Wisconsin Department of Transportation

NOTICE TO ALL CONTRACTORS:

Proposal #28: 1470-27-71

This is Addendum No. 02, which provides for the following:

| TEMPORARY TRAFFIC PEDESTRIAN TRAFFIC TRAFFIC TEMPORARY DETECTION CONTROL TRAFFIC SUBFACE TEMPORARY PEDESTRIAN WARRING PEDESTRIAN CONTROL TRAFFIC SUBFACE TEMPORARY PEDESTRIAN WARRING PEDESTRIAN DAY EACH SF NO. DEVICES DAY SF LF DURATION | 1000 45,000 |
|---|--|
| 643.0715 TRAFFIC CONTROL WARNING WARNING ARROW LIGHTS TIPE C. LIGHTS TIPE C. BOARDS NO. DEVICES NO. DEVICES | Addendum No. 02 ID 1470-27-71 Revised Sheet 92 February 5, 2025 |

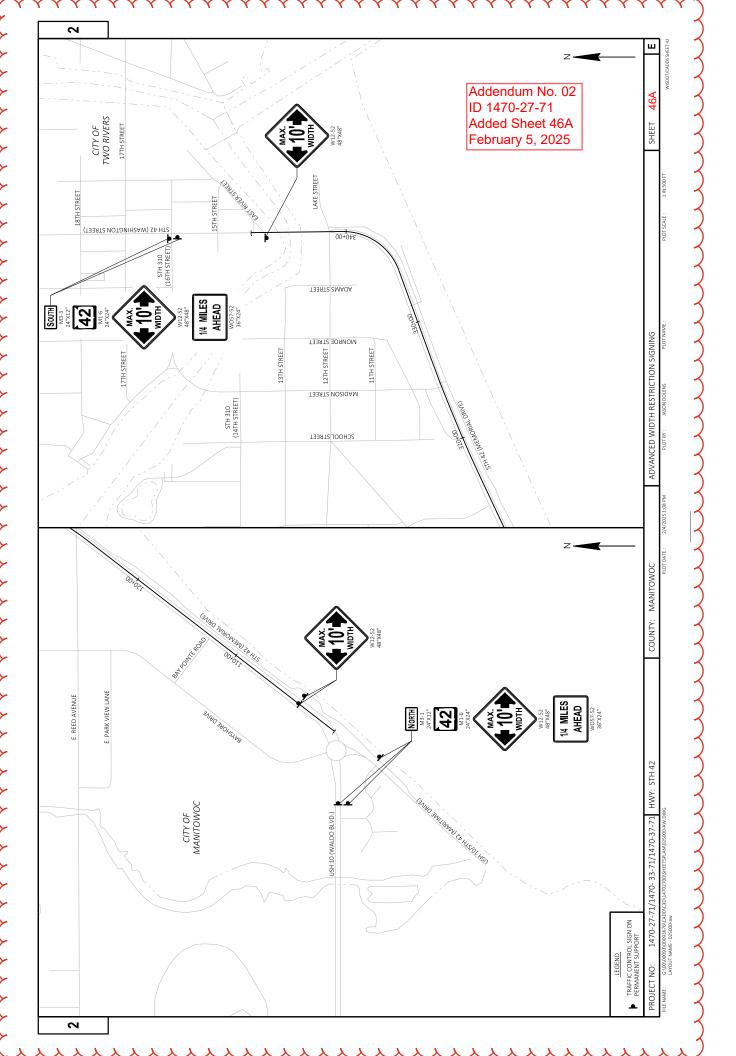
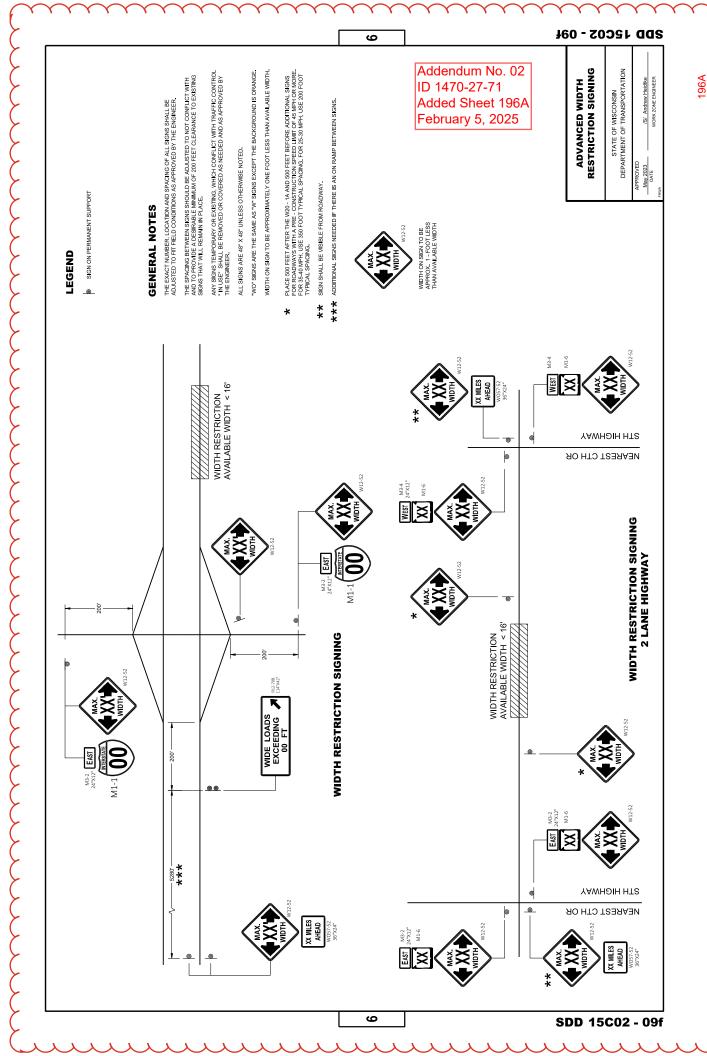
| Revised Plan Sheets | | | |
|---------------------|--|--|--|
| 92 | Miscellaneous Quantities (Added Traffic Control Cones 42-Inch bid item and modified quantities of other traffic control devices) | | |
